**PUD &
SUBDIVISION STAFF REPORT****Date: July 7, 2005****DEVELOPMENT NAME** D'Iberville Town Homes**SUBDIVISION NAME** D'Iberville Town Homes**LOCATION** South side of Southland Drive, 800'± West of Knollwood Drive, extending to the West terminus of Southland Drive**CITY COUNCIL
DISTRICT** District 6**PRESENT ZONING** R-3, Multi-Family Residential**AREA OF PROPERTY** 10.8 Acres 58 Lots**CONTEMPLATED USE** Amend a previously approved planned unit development to allow reduced lot size, widths, reduced building setbacks, increased site coverage, and on-street shared parking for a single-family residential town home subdivision.**TIME SCHEDULE
FOR DEVELOPMENT** Phase One — Immediately upon approval**ENGINEERING
COMMENTS** Must comply with all stormwater and flood control ordinances. Any work performed in the right of way will require a right of way permit.

SITE PLAN

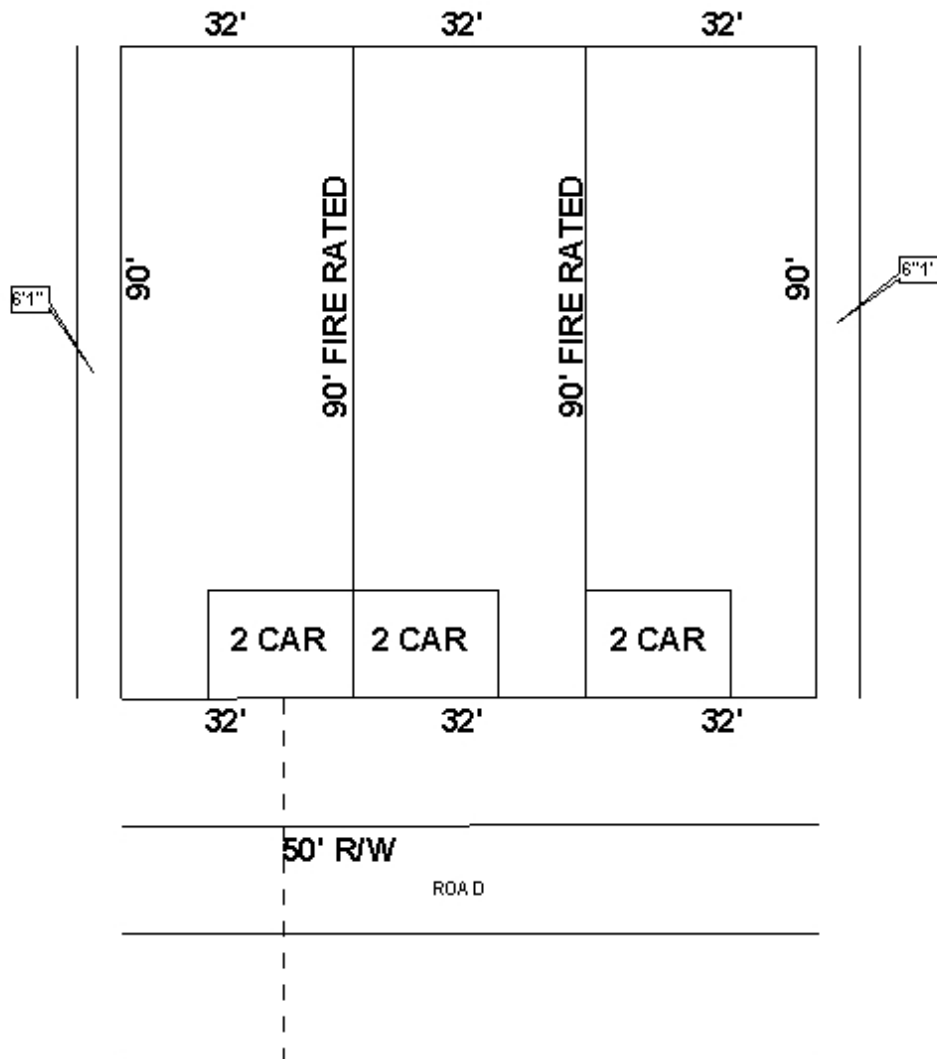
Roadway layout appears not to be City standard. Some cul-de-sacs do not have adequate ROW specified and curbing stated ("role-back") is not City standard. If streets are to be dedicated to and maintained by the COM, they must be constructed to City of Mobile standards.

Driveway number, size, location, and design to be approved by Traffic Engineering and conform to AASHTO standards. Head in parking that requires backing into the travel way is not allowed. Although right-of-way widths are shown, actual street widths are not given on the drawing and in some instances are not shown. Without this information, it cannot be determined if the shown turnarounds are adequate.

The first relates to the streets being dedicated, public streets and the on-street parallel parking as proposed. While on-street parking on minor residential streets may be allowed, consultation with Traffic Engineering would be appropriate if it is a design feature of the proposed development. In addition to the parallel spaces proposed, the plan reflects a number of “guest” parking spaces that back into the right-of-way. Based upon comments from both City Engineering and Traffic Engineering, the streets as proposed do not appear to comply with City of Mobile construction standards, and the parking spaces that back into the street are not allowed.

With regard to the dwelling units, the individual “buildings” will have either two or three town houses per building and in most instances there will be a common or service area between the buildings. The PUD Section of the Zoning Ordinance requires a minimum separation of 8 feet between two-story buildings, and windows would not be allowed on the exterior walls flanking the common or service areas unless the minimum separation required by the Zoning Ordinance is provided.

PUD approval is site plan specific. Therefore, given the concerns regarding road construction standards, parallel parking and parking that backs into the street; and the impact that easements and buffers requested by the Engineering Department could have on the development, a holdover to allow the applicant to meet with Engineering and Traffic Engineering to address these issues and submit a revised plan would be appropriate.
